December 10, 2019
Medway Planning & Economic Development Board
Meeting

Choate Trail Way Definitive Subdivision
Plan Public Hearing

- Public Hearing Notice dated 11-21-19
- Abutter Notice dated 11-22-19
- Subdivision Application
- Development Impact Report
- Definitive Subdivision Plan dated 11-8-19 by Connorstone Engineering
- Historical Commission Demolition Approval dated 5-2-19
- SAC memo dated 12-3-19 to Town staff requesting review and comments
- PGC plan review comments dated 12-4-19

JOB No.	16,529
DATE:	SEPT. 16, 2019
SCALE:	1"=20'
SHEET:	4 of 6
PLAN #:	27,355

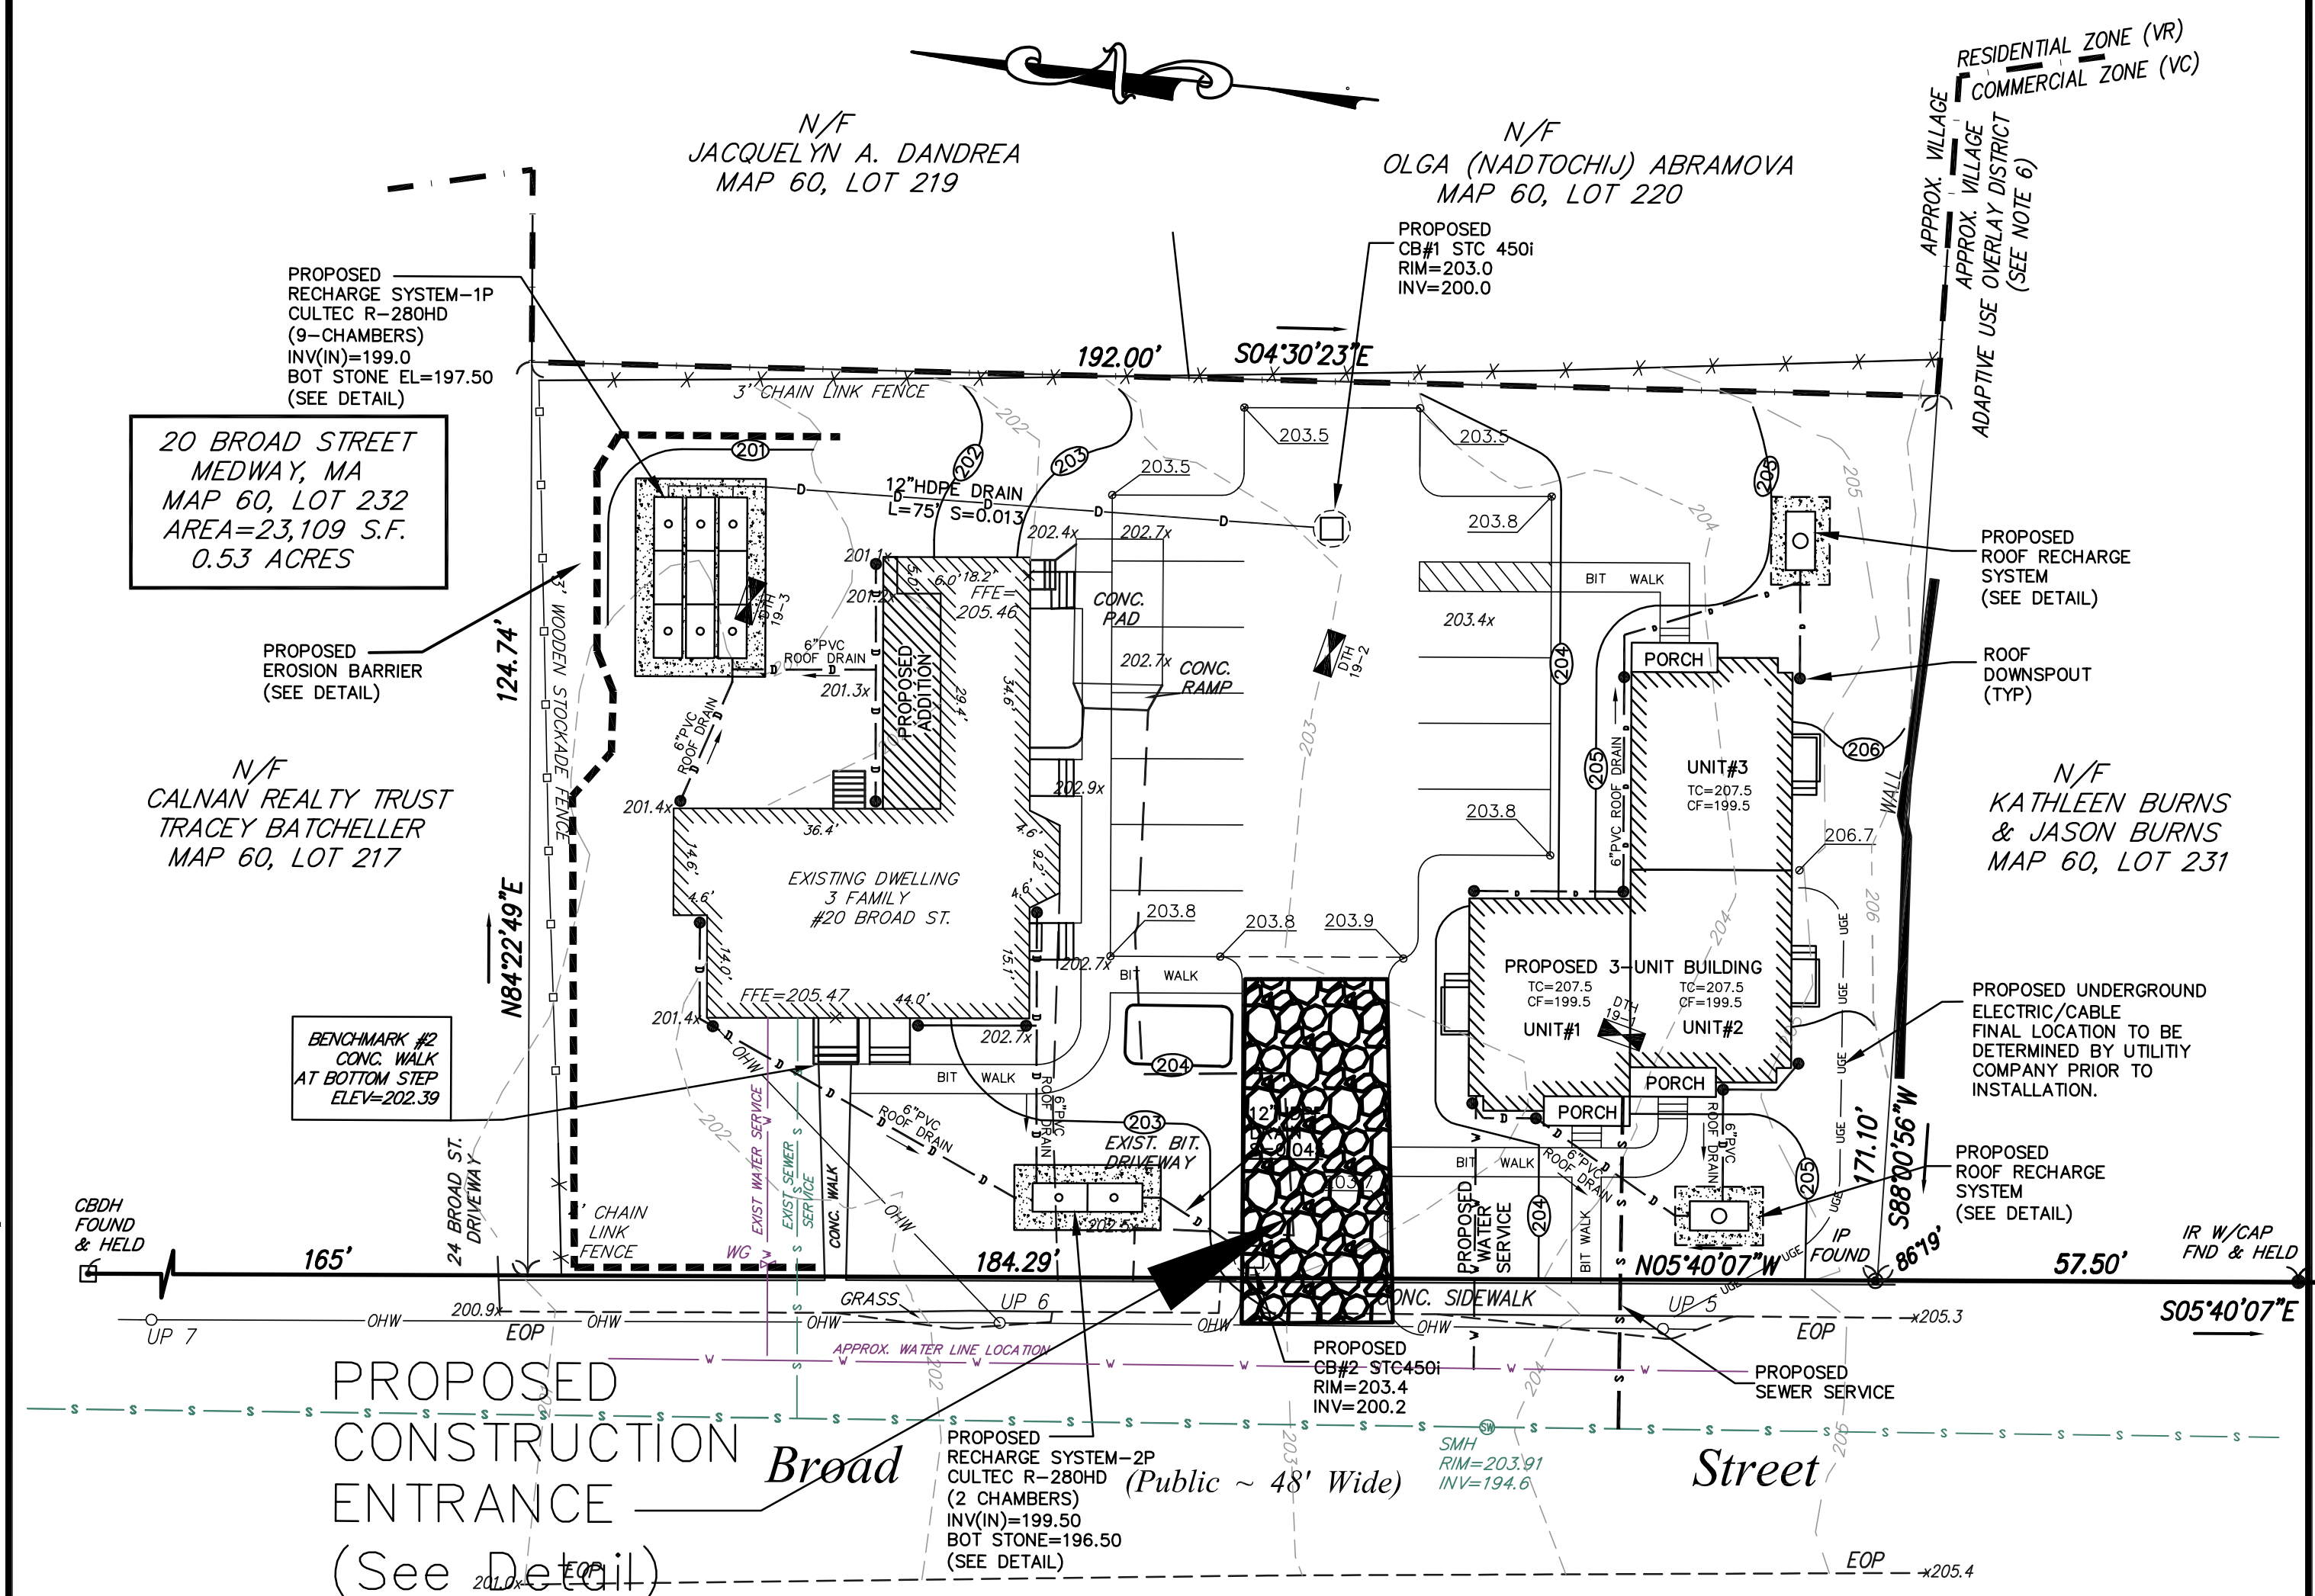
25. Revised Erosion control extended. See Sheet 4.

- *GLM 11/22/19 Response: Revised erosion control extended. See Sheet 4.*
 - TT 12/4/19 Update: In our opinion, this item has been resolved.
